REQUEST FOR CITY COUNCIL CONSIDERATION

Agenda Item: 7C	Prepared by: L. Suzanne Pritchard, PLA, AICP, CFM	
Agenda Section: New Business: Ordinance. First Reading	Date: September 11, 2024	
Subject: Amendment to the Parkway Group Planned Development District (PDD) revising neighborhood three (Wax Myrtle) at Waterside [Z-24-30]	Division: Planning and Development	
<u>Proposed Changes:</u> The applicant, Robert “Shep” Guyton, acting as the agent for the Developer, has requested an amendment to the Parkway Group PDD for the Wax Myrtle neighborhood. The amendment proposes a new layout for the Wax Myrtle neighborhood, which includes a single stream crossing via a bridge and an increase in the number of dwelling units to 100. The bridge will feature a three-lane section to enhance maneuverability and address stream flow issues, which were a concern with the previously proposed box culverts. The proposal has been attached for Council’s review. <u>Staff Review:</u> The amendment has been reviewed by the Department of Public Works, Department of Public Safety, and the Department of Planning and Development; no concerns have been expressed. <u>Planning Commission Action:</u> The Planning Commis

Existing Entitled Plan

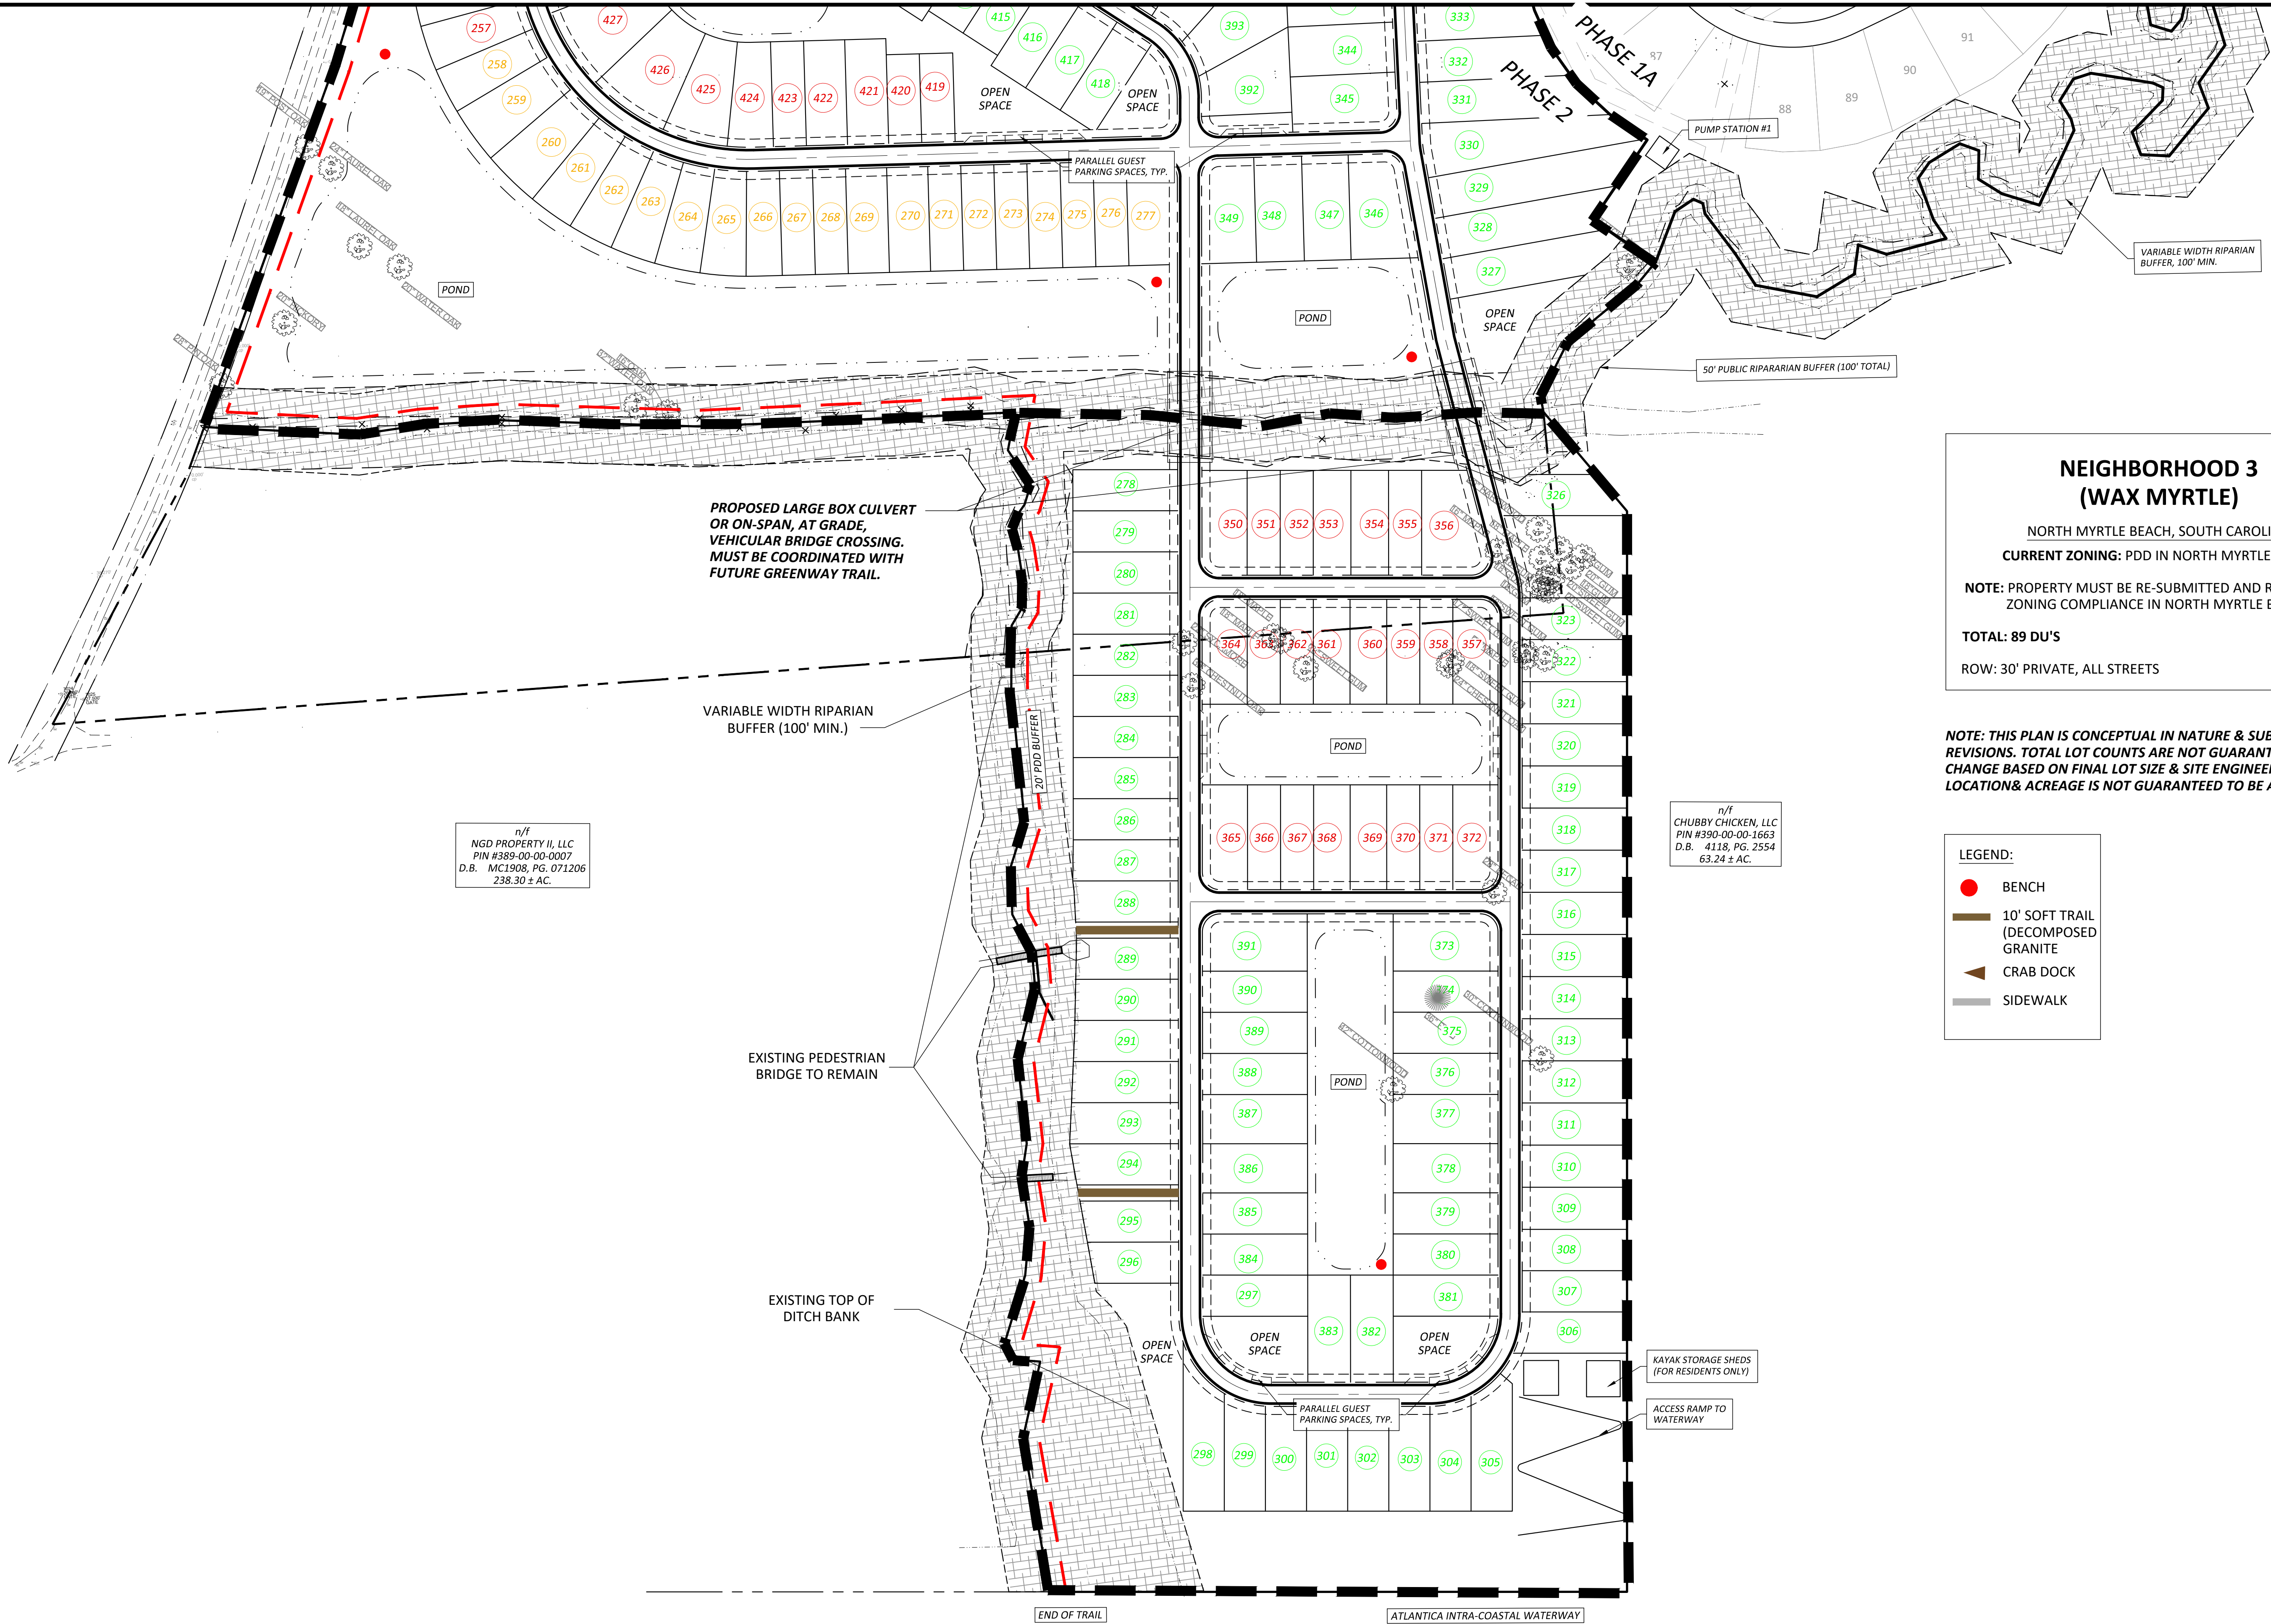
On May 17, 2022, the City Council approved the major amendment creating the Wax Myrtle neighborhood at Waterside. The originally proposed neighborhood had 89 dwelling units and two connections to the rest of the Waterside development, box culverts crossing the Long Branch stream/riparian buffer. During the entitlement process, at the request of the planning commission, the applicant removed two lots to save a large stand of protected trees near one of the proposed crossings.

The Planning Department has no issue with the proposed amendment but notes a reconfiguration of the neighborhood could save the large stand of trees that the planning commission originally protected. By removing the short leg of road requiring a cul-de-sac for trash pick-up, the neighborhood would still have an increase in density of 10 units and the trees would be protected.
